**The Bay Institute
Defenders of Wildlife
Natural Resources Defense Council
Pacific Coast Federation of Fishermen's Associations
Golden Gate Salmon Association**

November 9, 2017

RE: COMMENTS ON THE FINAL PHASE 2 SCIENTIFIC BASIS REPORT

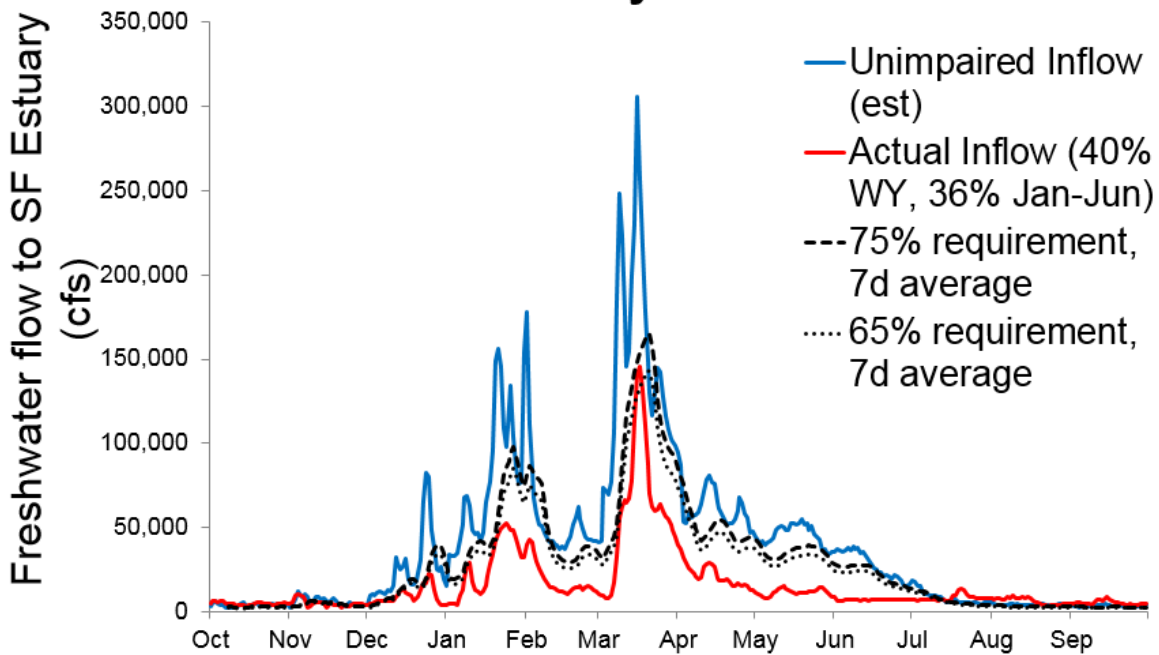
A requirement based on a trailing 7-day average unimpaired Delta outflow (for example) calculated in this way would result in the following hydrographs for 2015-2016 (65% and 75% of unimpaired Delta outflow is used in these examples). In 2016, the highest peak flow required under a 65% UIF was achieved; however the rest of the Jan-Jun period would have required additional releases. In 2015, higher flows would have been required for most of the Jan-Jun period. For both the 65% and 75% scenarios, the 7-d required line is usually below the 1-d unimpaired line; therefore most of the time reservoirs would simply release a larger proportion of inflow. Releases from storage would only be required briefly following high inflows due to the 7-day averaging.

Crangon

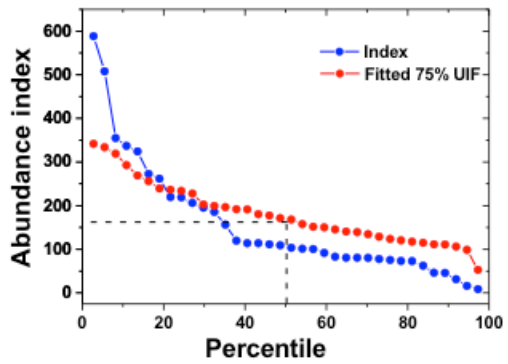
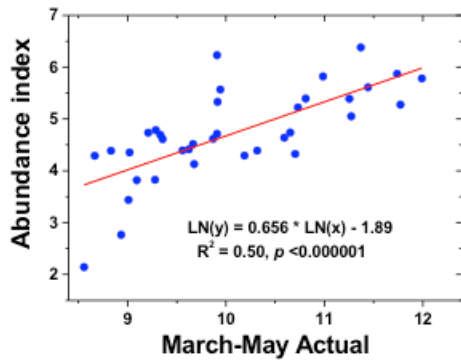
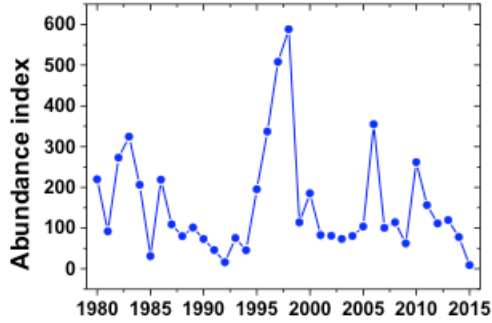
To illustrate our approach, we present the abundance distribution for Crangon shrimp that would be expected (based on flow abundance relationships for current Delta geometry and habitat availability) under a 75% March-May unimpaired flow regime. Specifically, we calculated the relationship between annual Crangon shrimp abundance indices from the Bay Study's midwater trawl and Delta outflow from March-May of the same year (we believe that these are the same data that were used to generate this relationship for the final Report's analyses of *Crangon* shrimp). The relationship is highly significant, has not changed through the period of record, and explains about 50% of the variation in Crangon abundance across years (see figure below). We then used estimates of 75%

March-May unimpaired flows (CDWR, 2016)¹ as inputs into the Crangon flow-abundance regression. The results, which represent expected population abundance of Crangon shrimp had March-May outflows been 75% of UIF during the period of record, were represented in an exceedence plot in the figure below. The 50% exceedence value (about 170) represents about a 37% increase in the median abundance of Crangon shrimp that we should expect if future flow and non-flow conditions provide levels of protection for this species that are equal to those we would expect under today's conditions with 75% unimpaired outflows. In addition, this technique provides valuable insights into the distribution of *Crangon* abundances under different hydrological conditions. This is much more informative than simply having one target value (e.g., the median). The SWRCB can use this wider array of abundance targets to identify different types of adaptive management response. For example, if *Crangon* shrimp populations fall below the median target (170) in more than 50% of years (perhaps based on 5-6 year running average), this might trigger (i) a review of the POI and/or (ii) specific actions identified in the POI that would be taken if *Crangon* abundance falls below 170 in any one year, because such levels should be extraordinarily rare if adequate requirements are in place.
